SOLANO COMMUNITY COLLEGE  KITCHELL MADI ARCHITECTURE + PLANNING	ADDENDUM #01
	Project: #16 – 007A Solano Community College District Horticulture Site Improvements
	Date: June 27, 2016

- ITEM 1: REVISED Sheet A2.5A (Farmers Stand)
DELETE Sheet A2.5A issued with bid and replace with **REVISED** Sheet A2.5A attached with this Addendum

- ITEM 2: REVISED Sheet A2.3A (Greenhouse)
DELETE Sheet A2.3A issued with bid and replace with **REVISED** Sheet A2.3A attached with this Addendum

- ITEM 3: REVISE Sheet FM-01 (Greenhouse)
DELETE Sheet FM-01 issued with bid and replace with **REVISED** Sheet FM-01 attached with this Addendum

SCALE : 1/4" = 1'-0"

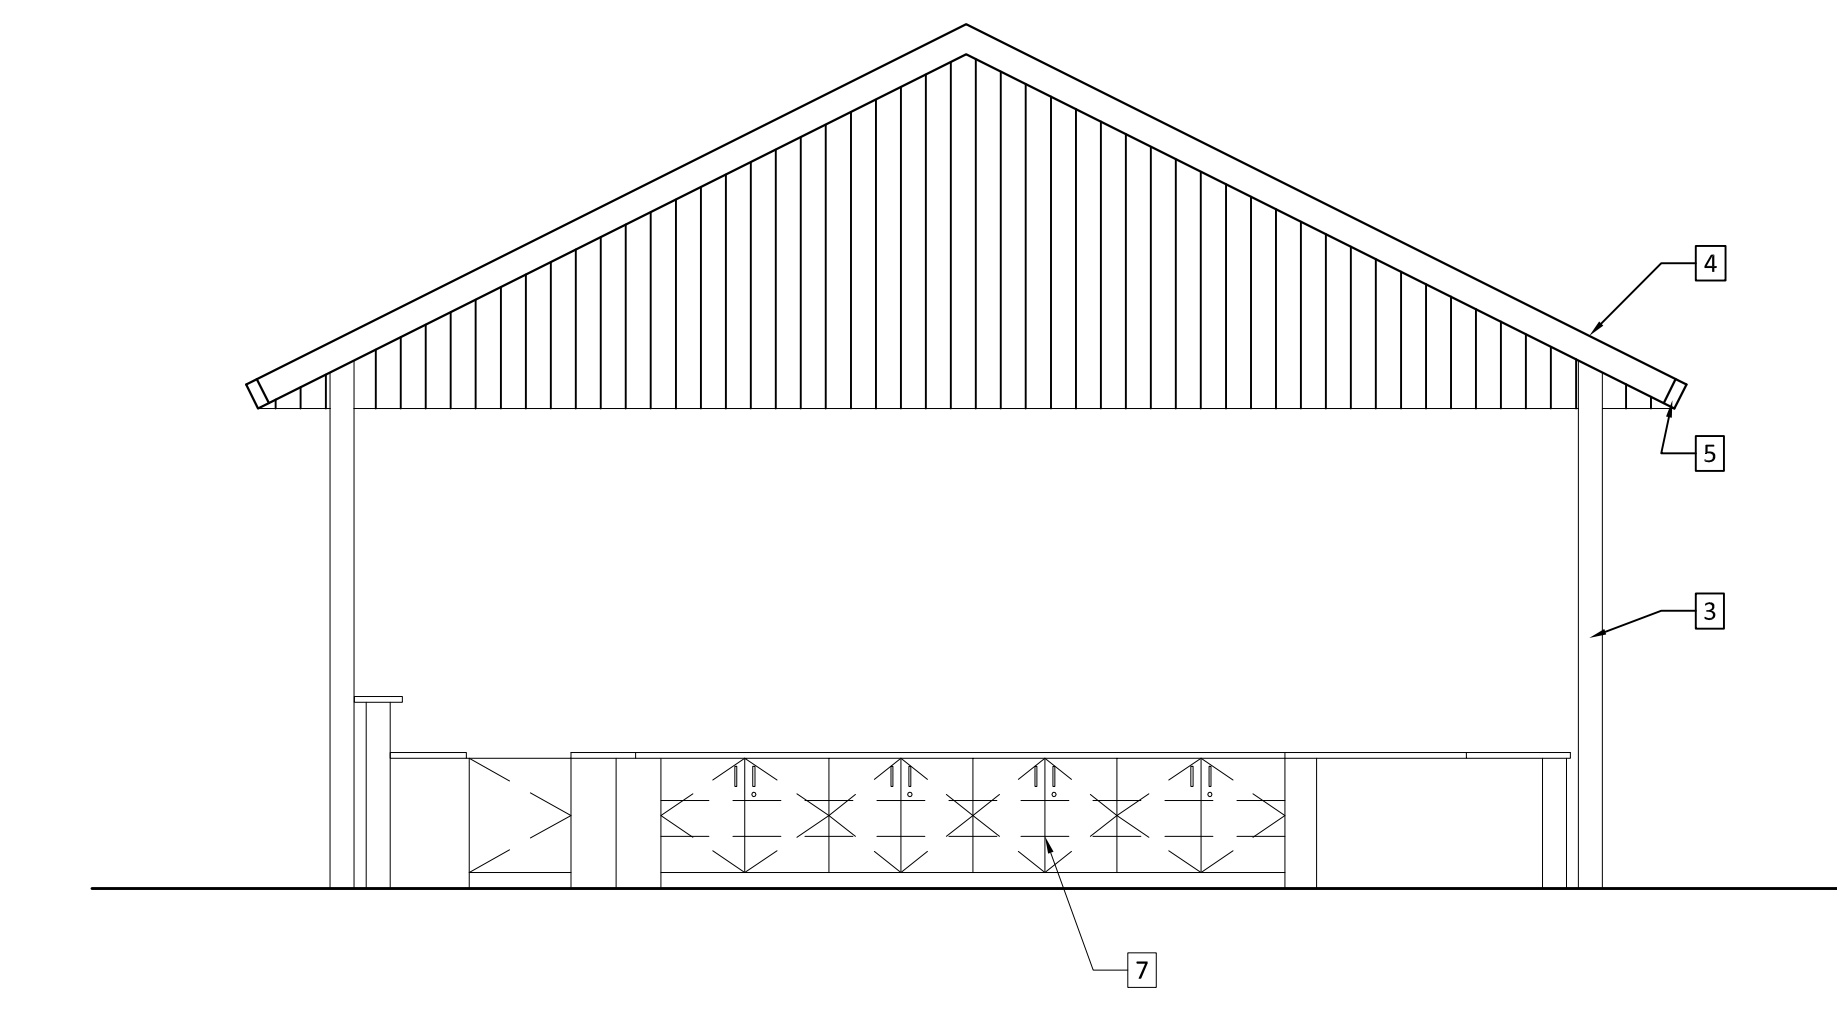
- 2. The description of alternate #2 mentions appliances. Please provide specification on the appliance(s) we are to include in this alternate.**

15. What is the gauge and finish of the stainless steel counter tops? Or please provide a specification.

16. Keynotes 8,9,10 are not defined on A2.5A yet 9 and 10 are called out. Please define.

17. No keynotes beyond 7 are defined however there are call outs for numbers beyond 7. Please define them.

A: See Section B, ITEM 1

A. See Section B, Item 1 for clarification on stainless steel counter tops

A. See Section B, ITEM 1

A. See Section B, ITEM 1

A2.3A

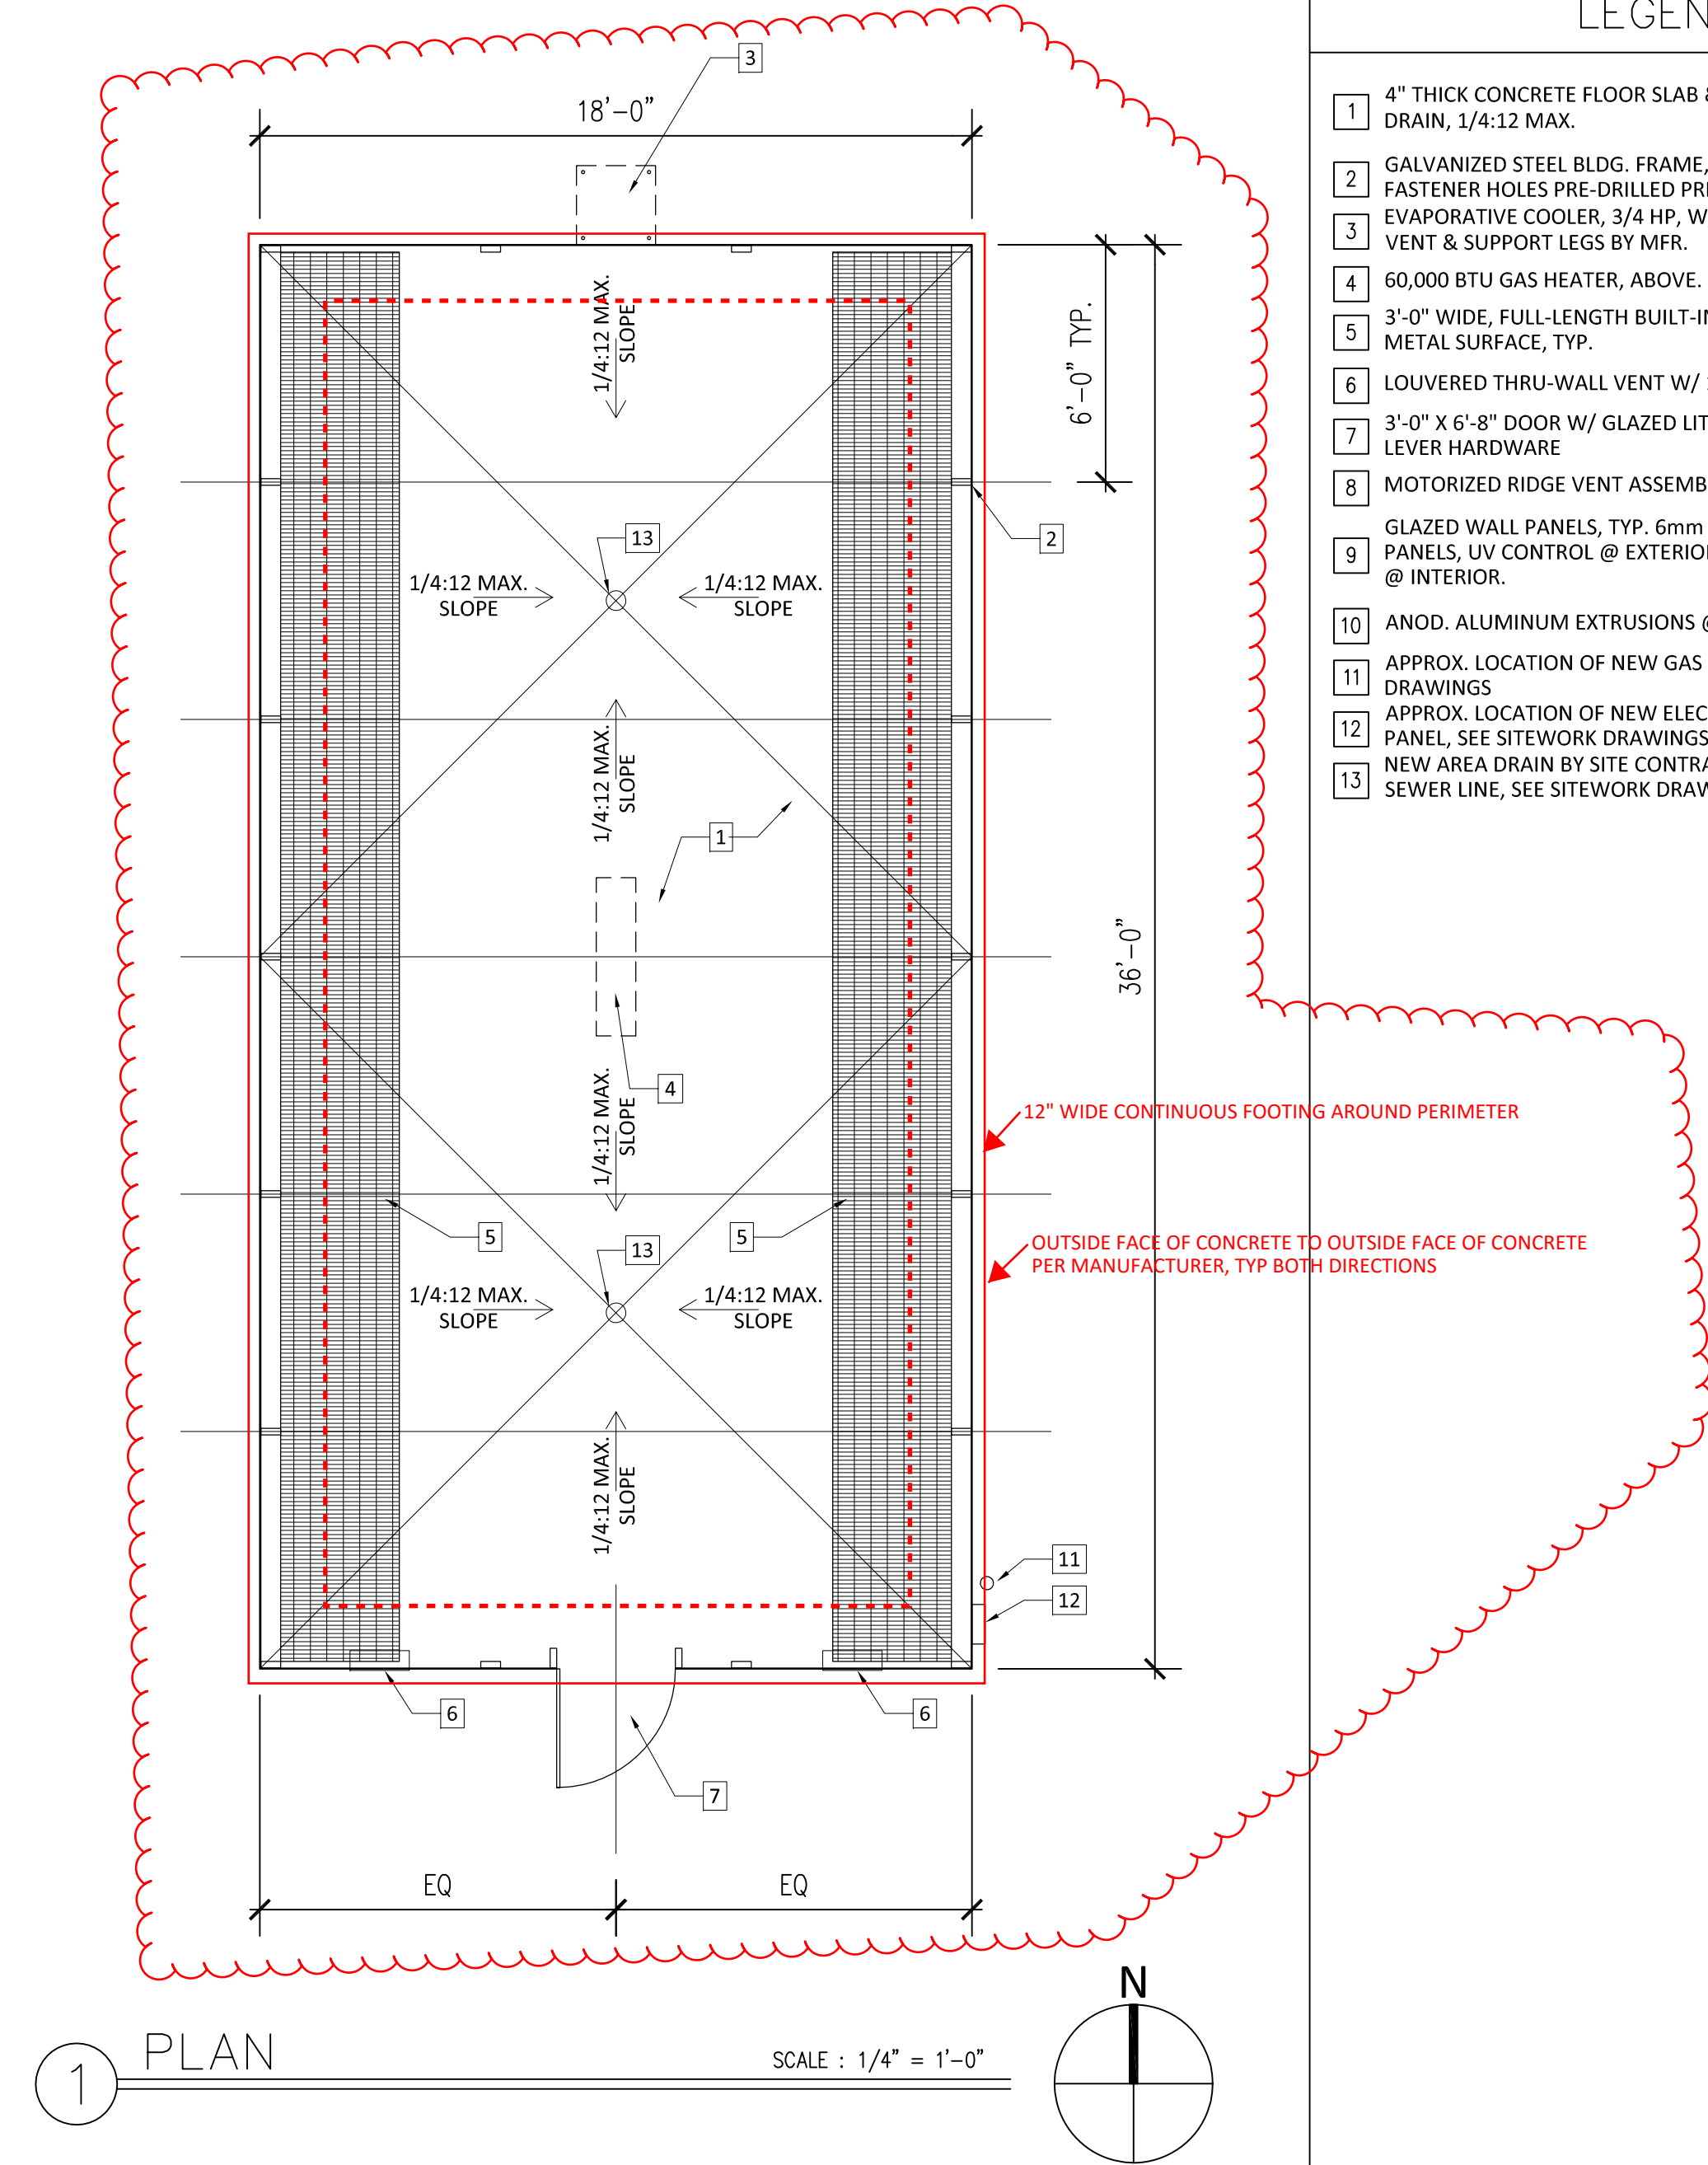
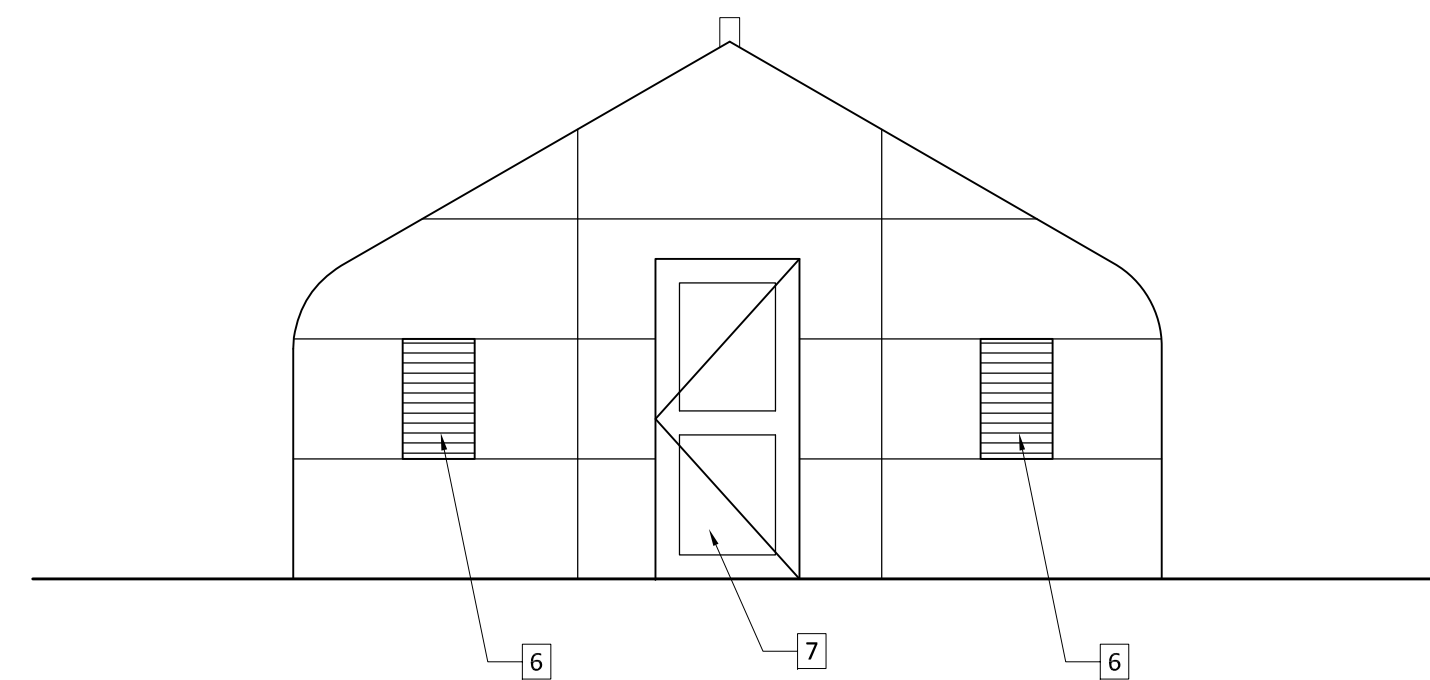
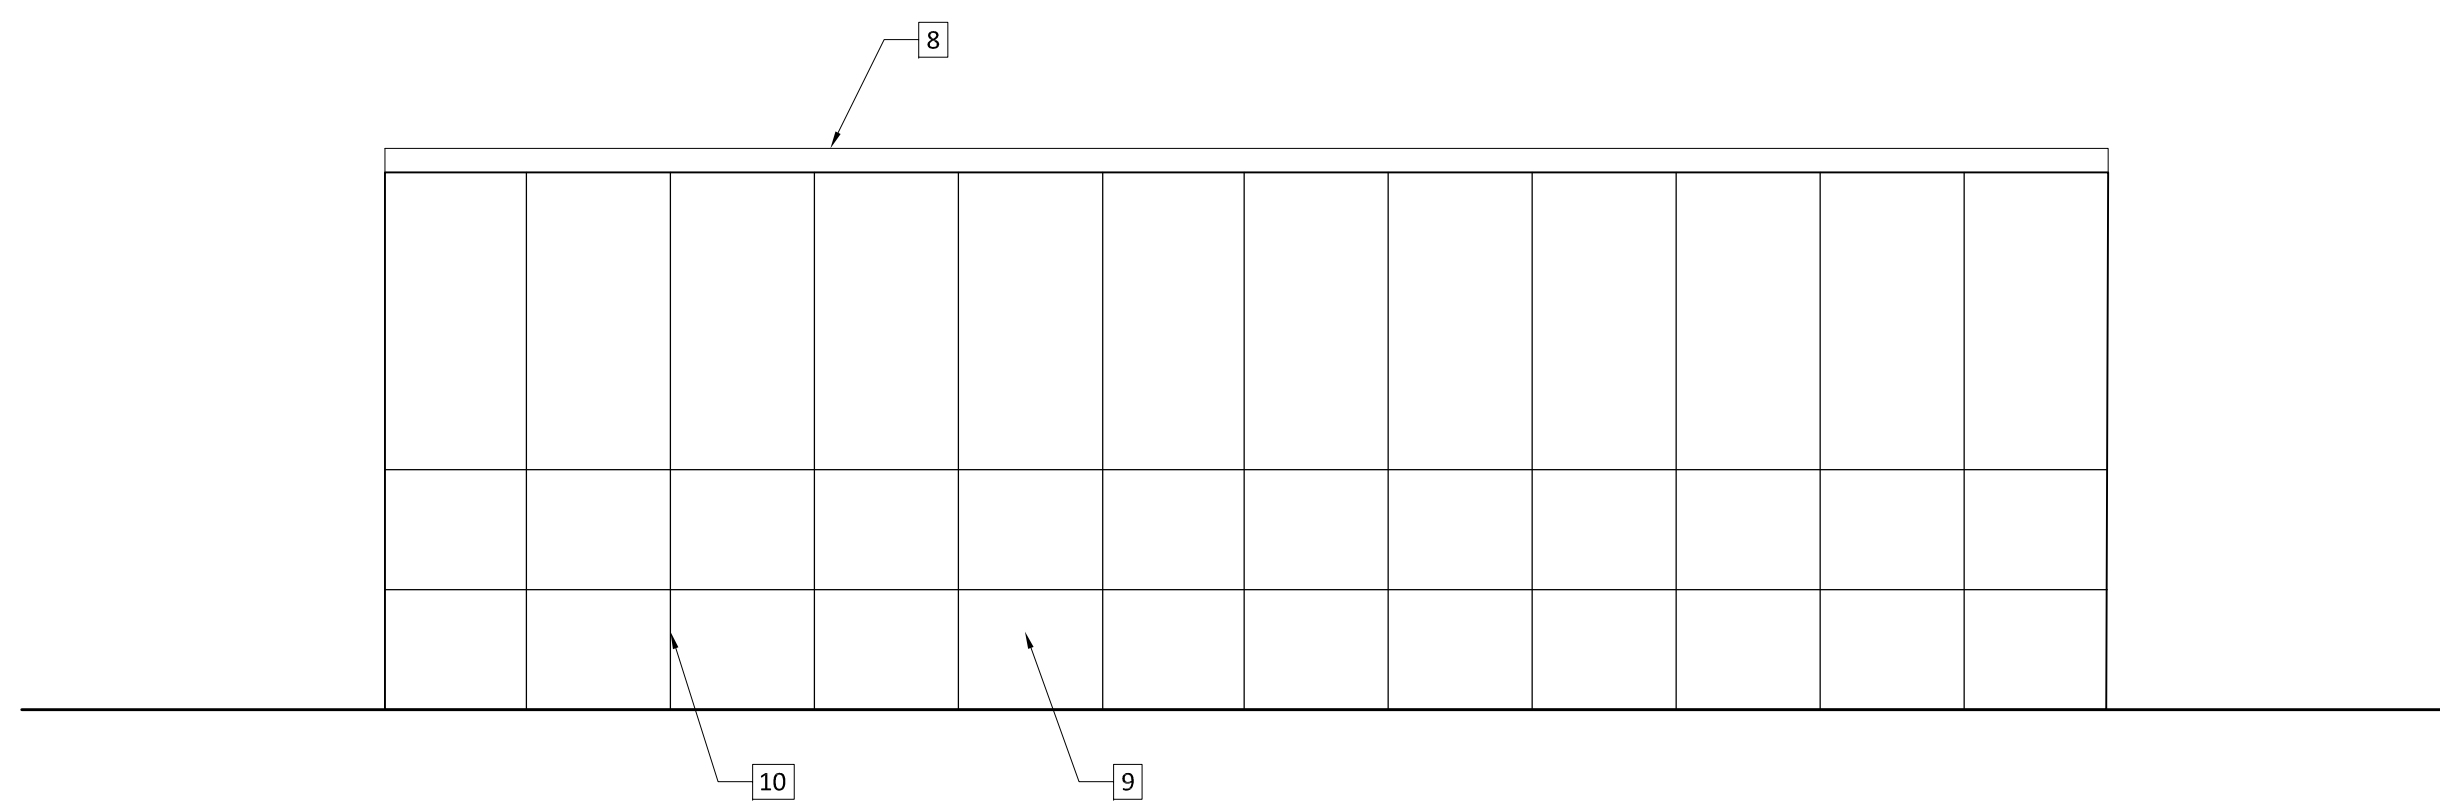
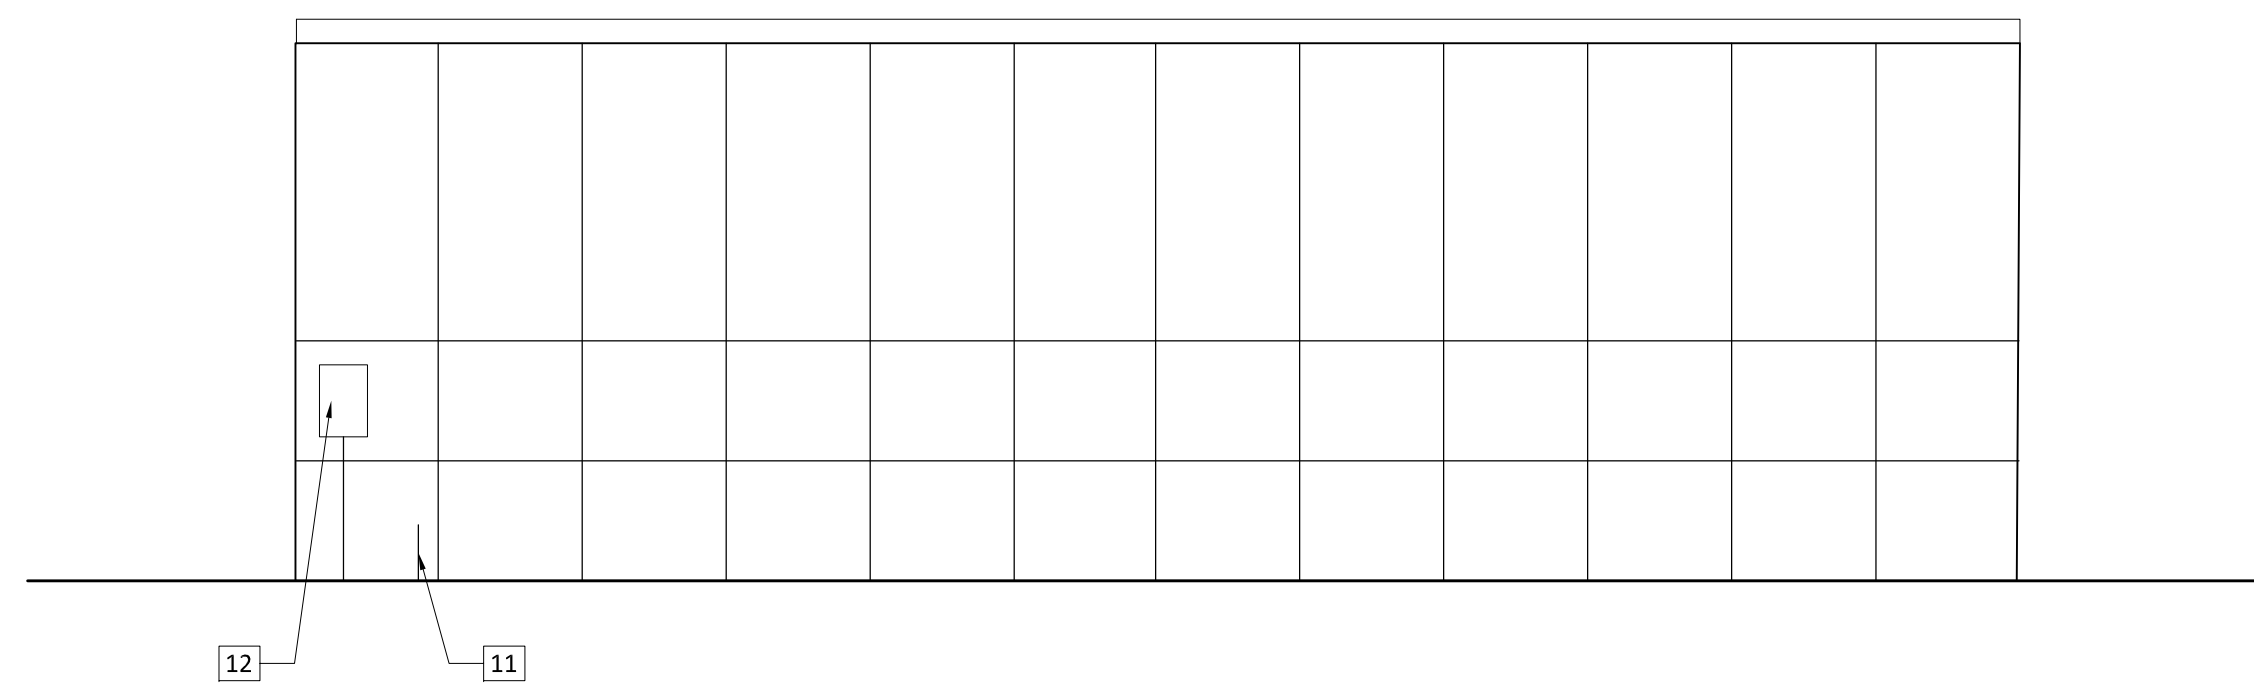
10. Slab footings for greenhouse are not shown however they are identified in note 1 as being required. Please provide width, depth, length and locations of footings.

A: See Section B, ITEM 2 and ITEM 3

12" WIDE CONTINUOUS FOOTING AROUND PERIMETER

OUTSIDE FACE OF CONCRETE TO OUTSIDE FACE OF CONCRETE PER MANUFACTURER, TYP BOTH DIRECTIONS
